3.0 CORRECTIONS AND ADDITIONS TO THE DRAFT EIR

1. CORRECTIONS AND ADDITIONS TO THE DRAFT EIR

2. Page 4.A-19, Figure 4.A-6, Landscape Site Plan, has been updated as shown on the following page.

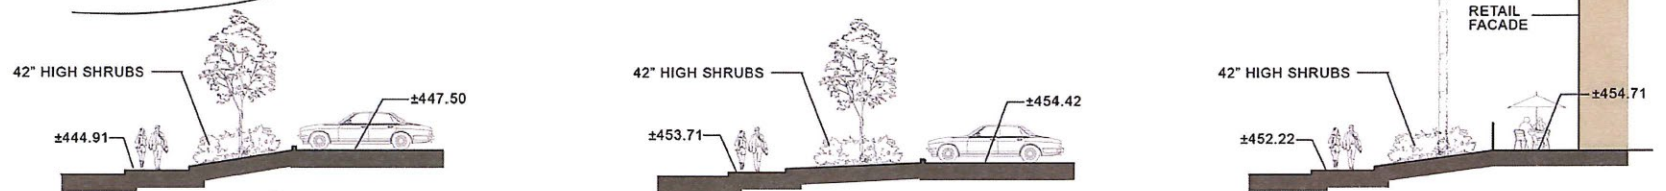
The Landscape Site Plan has been revised to correct the calculated landscaped area and to update the estimated landscaping water demand. The calculations provided on the Landscape Site Plan represent conservative assumptions concerning the applicable plant factors and irrigation efficiency.

Pomona California Irrigation Management Information System (CIMIS) Station #78 ETo = 59.7 inches
 Using a Plant Factor of 0.5 for bushes, groundcover and trees proposed and an overall irrigation efficiency of 0.75 (some drip, some bubblers and some micro-spray), the total irrigation system demand would be:
